TI_2206: Conversion ground electrode iCombi gas 10-1/1

iCombi 10-1/1

14/03/2022

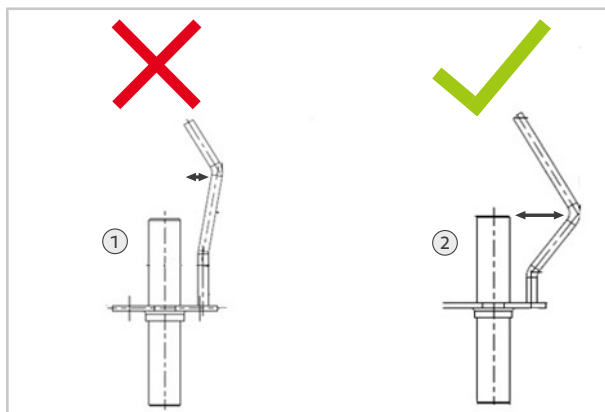
To ensure that the correct distances are maintained on the ground electrode, the ground electrode Part no.: 74.00.873P (1) has been replaced with Part no.: 70.01.574P (2). Part no.: 70.01.574P (2) is now also available as a service part for the iCombi Gas 10-1/1 (hot air blower).

When servicing an iCombi Gas, 10-1/1 only install Part no.: 70.01.574P (2) in the hot air blower.
